Metropolitan Washington
Council of Governments

Metropolitan Branch Trail Upgrade

Preliminary Design Report
May 2023

ROADWAY PLAN			
SCALE	1"=20'	DATE	MAY 2023
CONTRACT NO.	21-093-TLC		
DESIGNED BY	AMA	COUNTY	MONTGOMERY
DRAWN BY	MEG	LOGMILE	
CHECKED BY	RJG		
F.A.P. NO.	T.B.D.		
DRAWING NO.	HD - 05	OF	06
SHEET NO.	09	OF	16

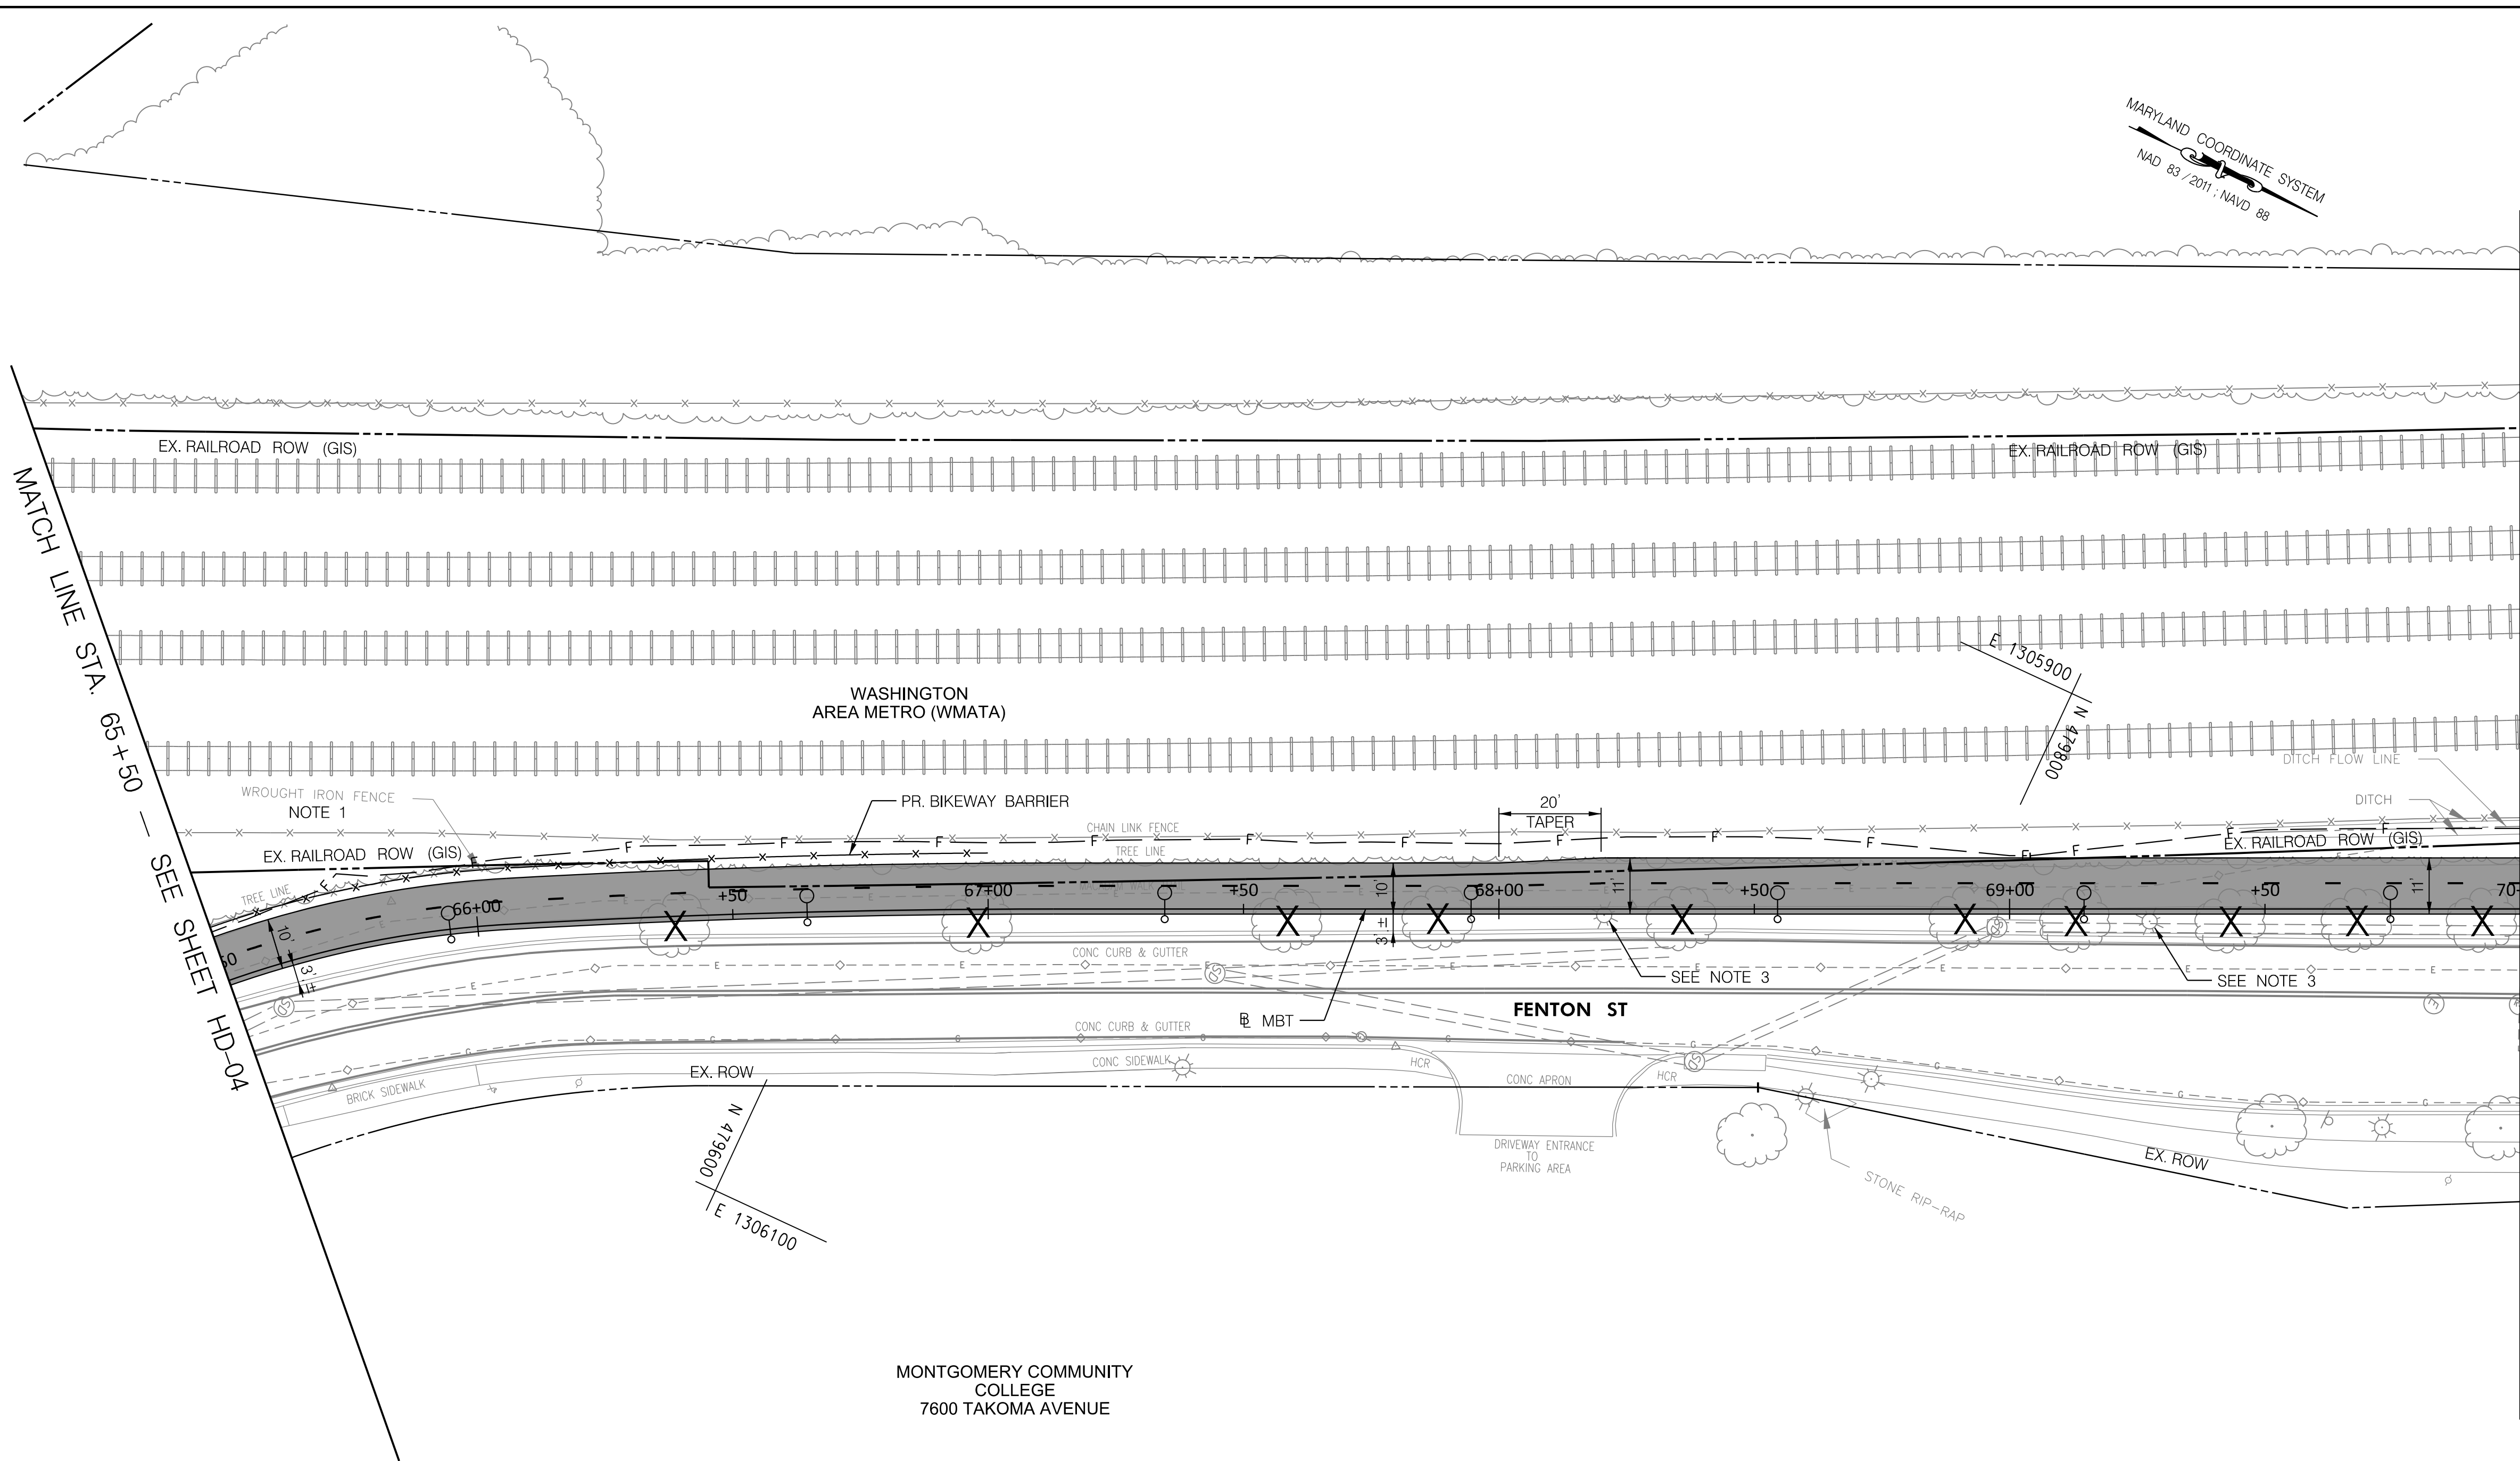
7	8,9	<p>Northbound cyclists should be able to connect more directly to the southern end of the Montgomery College campus. Recommend two alternatives that could provide more direct access across Fenton St to the campus without cycling all the way up to New York Ave: (1) An addition of a trail extension that follows Takoma Ave all the way to Fenton St (so it meets up at the intersection of those two roads and the Macadam Trail). In addition, Macadam Trail should be widened, and the intersection crossing should be designed to provide safe crossing for cyclists and pedestrians. Please see the attached image (2023-02-21_MBT_Plans_Page_08_MontCollegeSouthernConnectionTrailExtension.jpg). (2) A crossing from the trail opposite the entrance to the Montgomery College parking lot shown on page 9. This would need to be a raised crossing and provide space for bicycle passing movements in addition to space for people waiting to cross the street. Please see the attached image (2023-02-21_MBT_Plans_Page_09_SouthMontCollegeCrossing.jpg)</p>	<p>Proposed alignment will be discussed with the City during the next design stage to determine if this route will be implemented into the MBT upgrades design. The proposed crosswalk is a mid block crossing and will require a review to determine if it is warranted.</p>
